Errata: CS4341 Rev. B**CS4341 24-Bit, 96 kHz Stereo DAC with Volume Control**

All references to the CS4341 mentioned below shall be taken to refer to revision B of the CS4341 product. The hardware revision code can be found in the 10 character field printed below the part number on each chip. The letter which appears as the fifth character from the right is the revision code (e.g. ZNAXYB9846 is a Revision B part).

Figure 1. I²C SCL Buffer Example

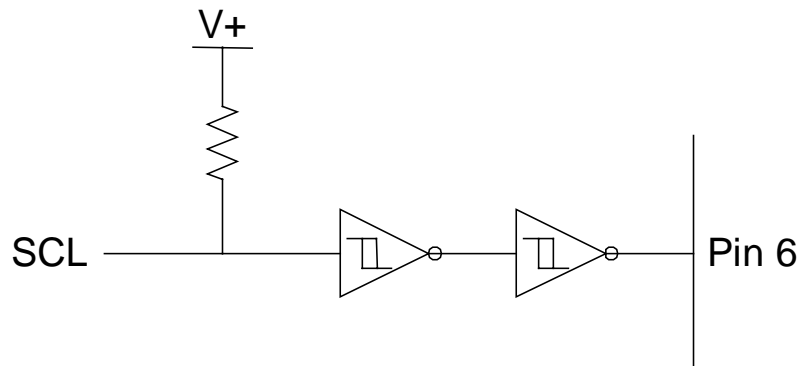
Pin 6 (SCL/CCLK) of the CS4341 does not have sufficient hysteresis to meet the data sheet rise time specifications. The I²C rise time t_r and the SPI rise time t_{r2} must be less than 30 ns for proper operation. This prevents the use of standard I²C configurations with a resistor pull-up. This problem can be worked around by placing a Schmitt Trigger buffer, for example a 74HC14, on the SCL line just prior to the CS4341. This will not affect the operation of the I²C bus as pin 6 is an input only.
